**From:** Lupe Carrasco <LCarrasco@yatespetroleum.com>  
**Sent:** Tuesday, July 02, 2013 11:46 AM  
**To:** 'mburton@blm.gov'; Bob Asher; Katie Parker; Amanda Trujillo  
**Cc:** Bratcher, Mike, EMNRD; 'jamos@blm.gov'  
**Subject:** Re: Mimosa SWD #1

**From:** Burton, Michael <mburton@blm.gov>  
**Sent:** Tuesday, July 02, 2013 10:59 AM  
**To:** Lupe Carrasco  
**Cc:** Bratcher, Mike, EMNRD; James Amos  
**Subject:** Re: Mimosa SWD #1  
**Attachments:** P6280264.JPG; P6280266.JPG; P6280263.JPG

YATES PET MILLMOSE SWD #1

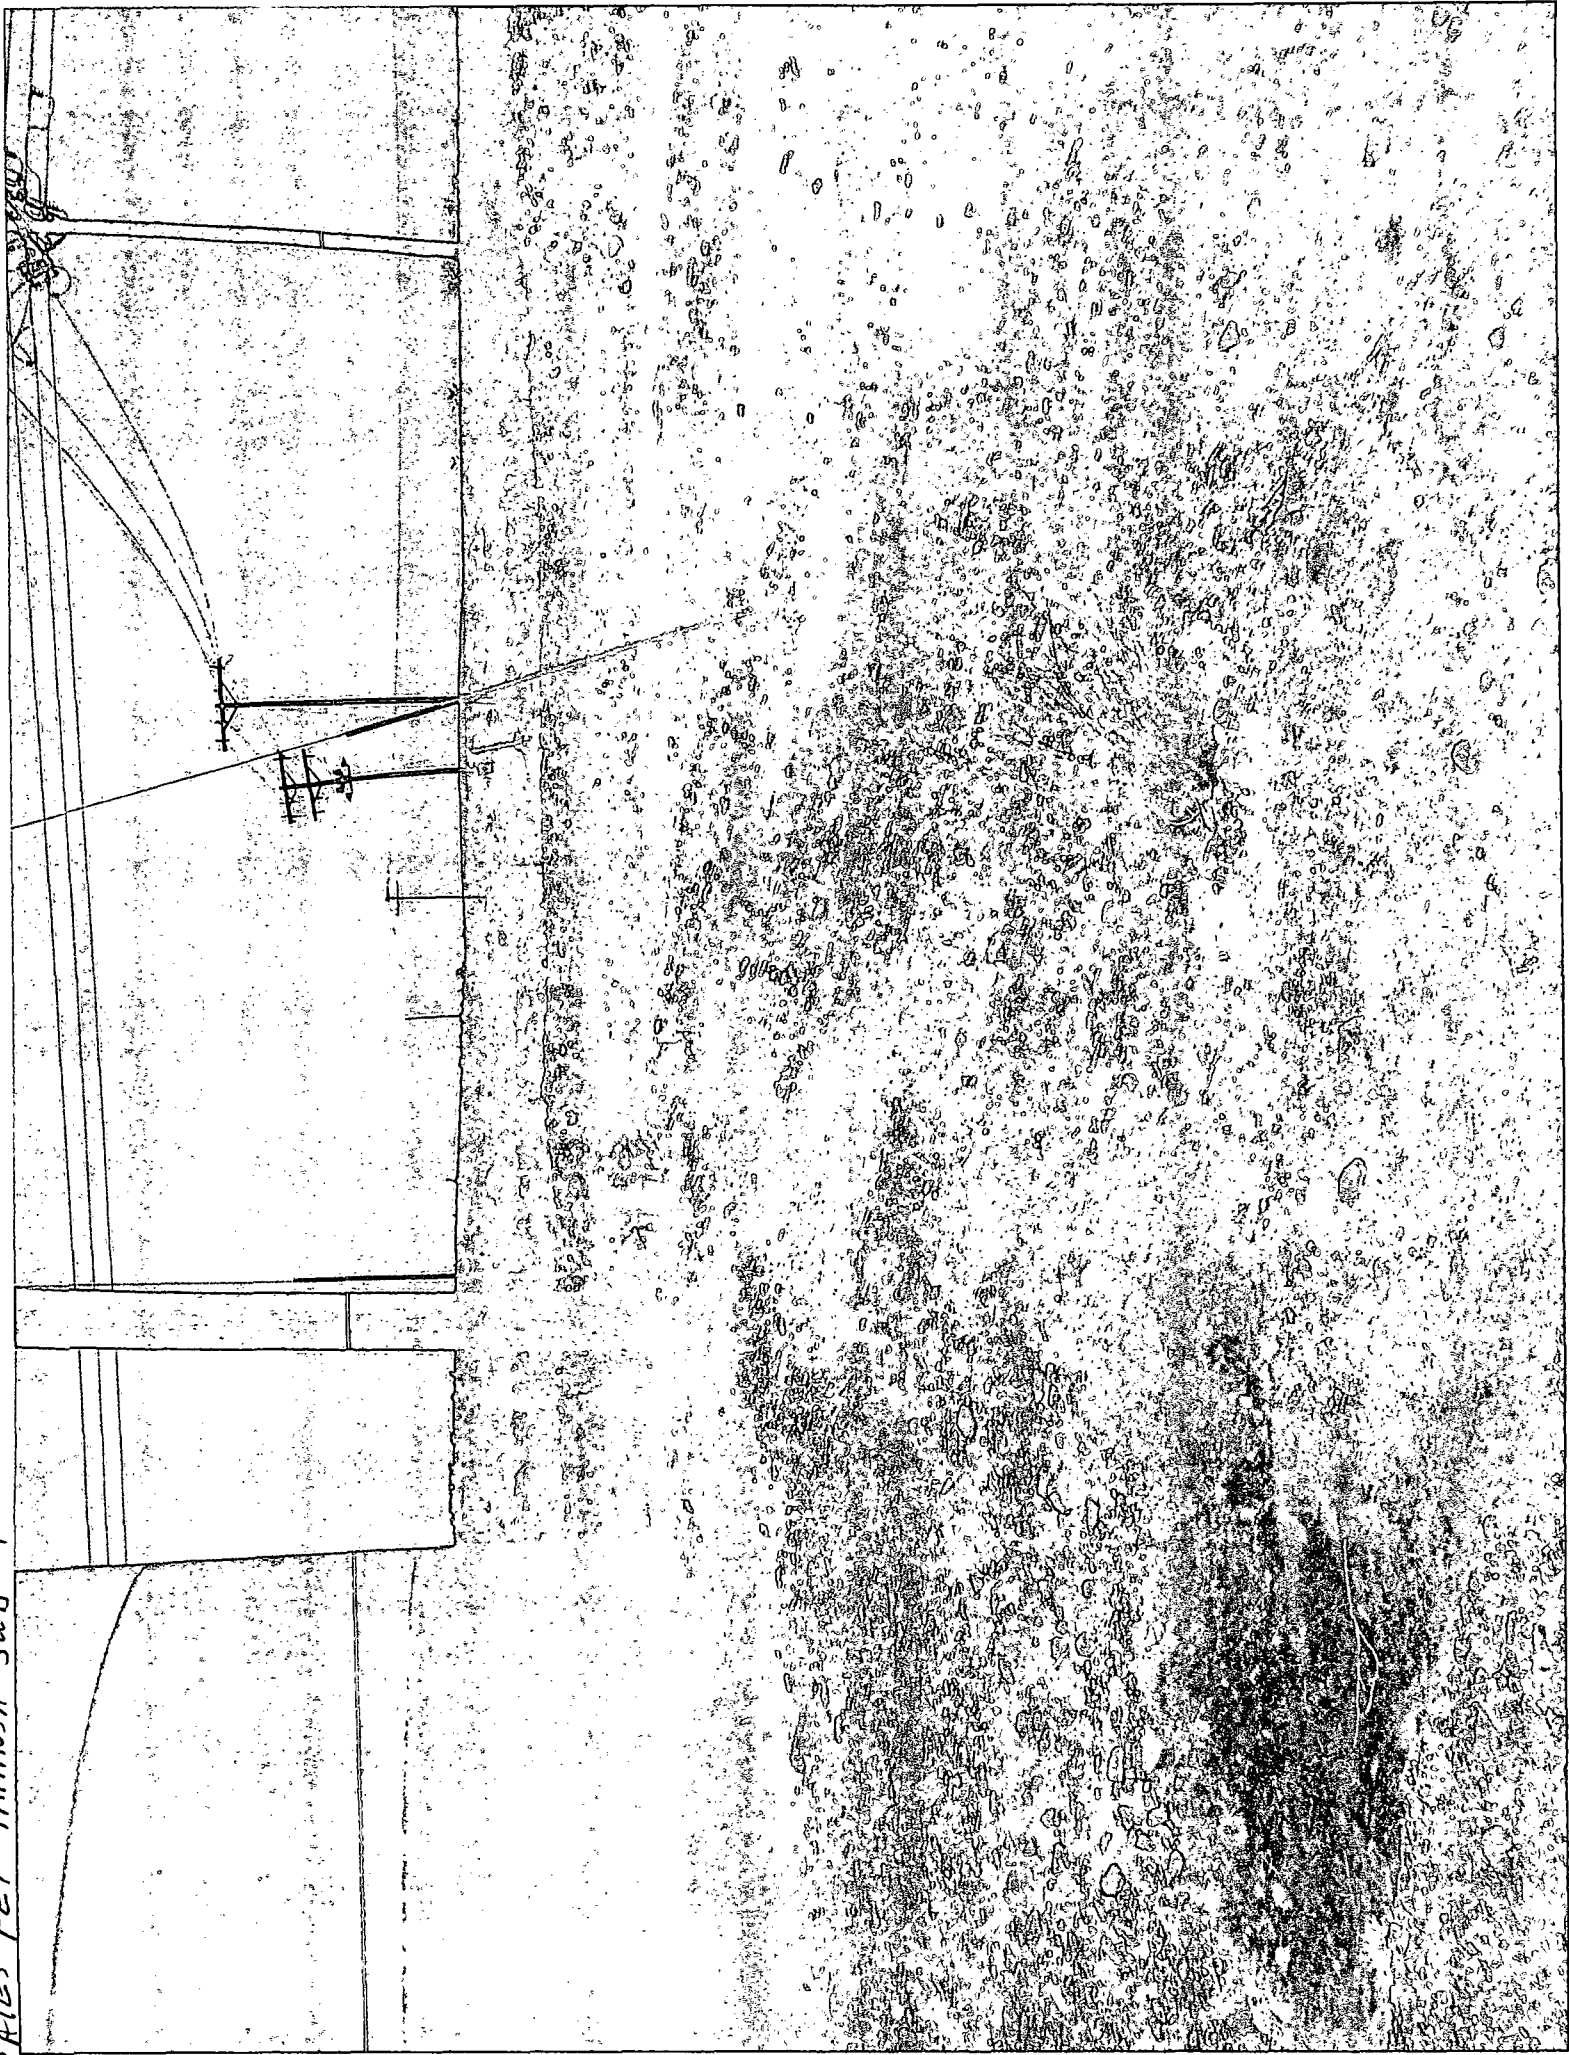
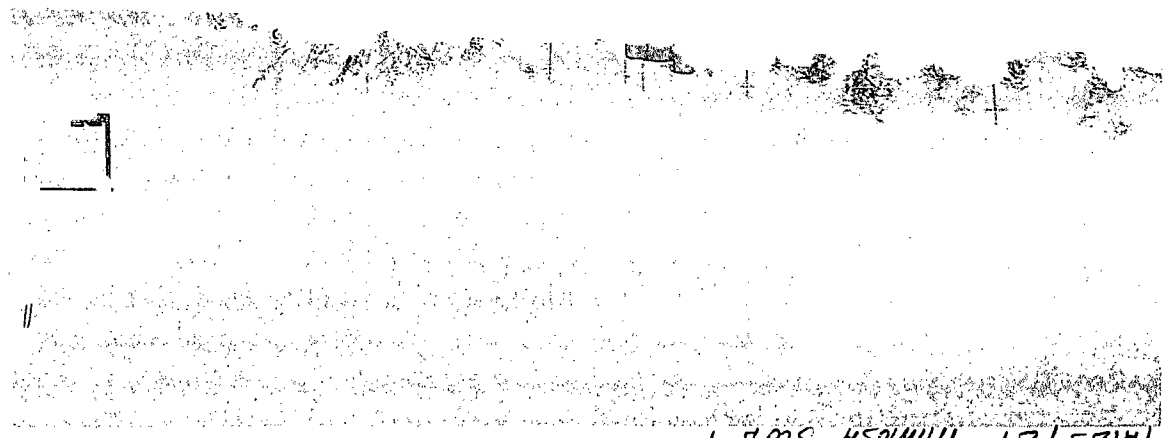
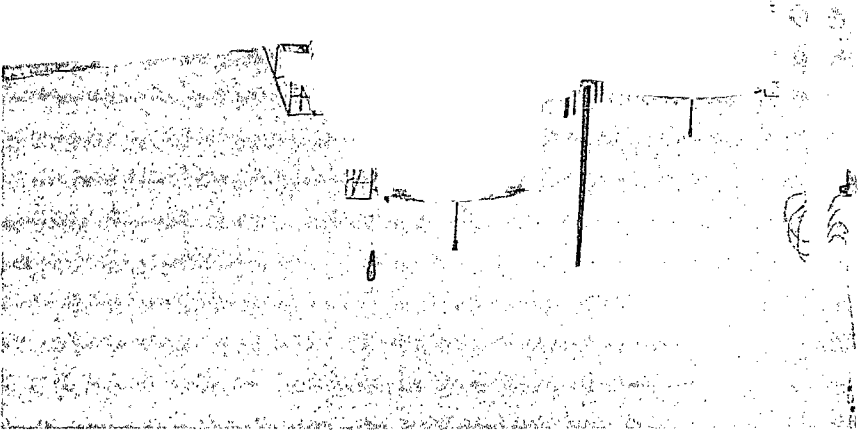
Lupe,  
On 06/28/2013 I stopped by the Mimosa SWD spill. There was a back hoe working in the S1 area. My concern is the S2 area. The sidewalls are not clean. You can see this in the pictures that are attached. I realize the safety issues with digging around the tanks but the outer sidewalls still need to be removed.  
Thanks

The crew was going to take care of that area as well. I'm out this week, but if it is not done when I get back I will have it taken care of then. I'll let you know.
